**In the matter of the  
Lal Lal Wind Farm Amendment Application  
Planning Panels Victoria  
Proponent: West Wind Energy Pty Ltd**

**Expert Witness Statement of  
Christophe Frederic Delaire**

Figure 1: Noise contour map showing properties listed in the Peer Review Report

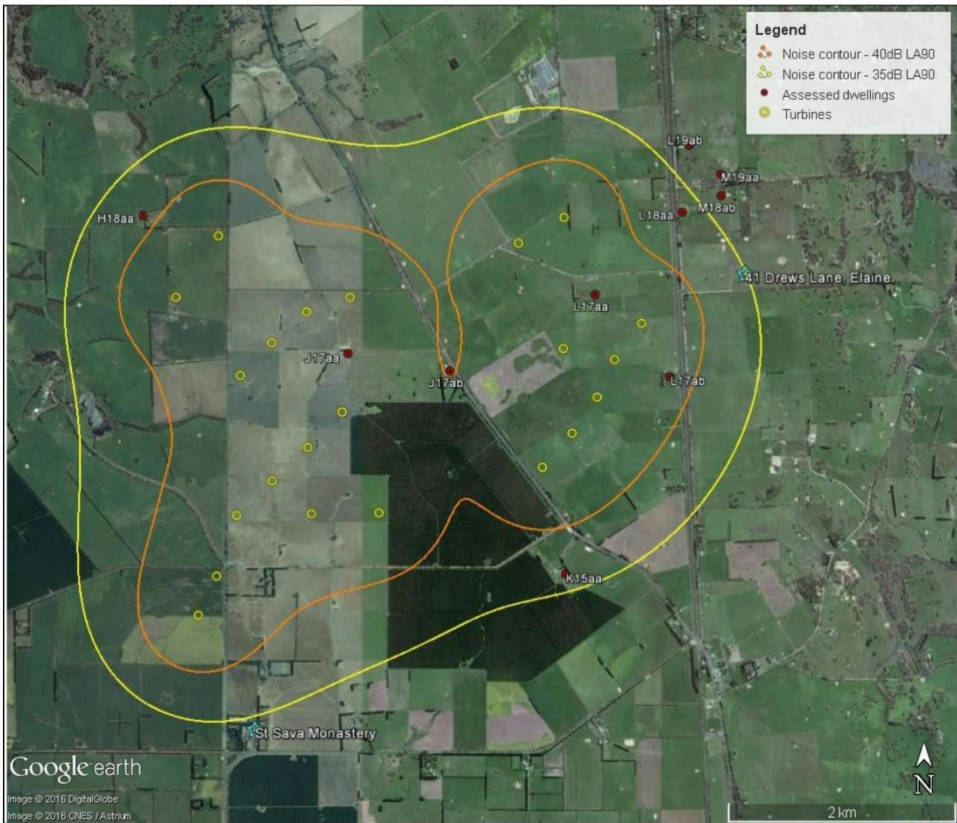
WestWind Energy has advised that the dwelling at 41 Drews Lane, Elaine did not exist at the time when the original planning permit was issued<sup>3</sup>. This dwelling is therefore not considered a relevant noise sensitive location in accordance with Condition 23 of the original planning permit which states:

Notwithstanding this, as indicated in Figure 1, noise levels from the Lal Lal Wind Farm at this dwelling are predicted to be 35 dB  $L_{A90}$  in accordance with the methodology detailed in Section 7.0 of the MDA Report.

As indicated in the noise contour map provided in Figure 1, noise levels from the Lal Lal Wind Farm at the St Sava Monastery are predicted to be 34 dB  $L_{A90}$  in accordance with the methodology detailed in Section 7.0 of the MDA Report.
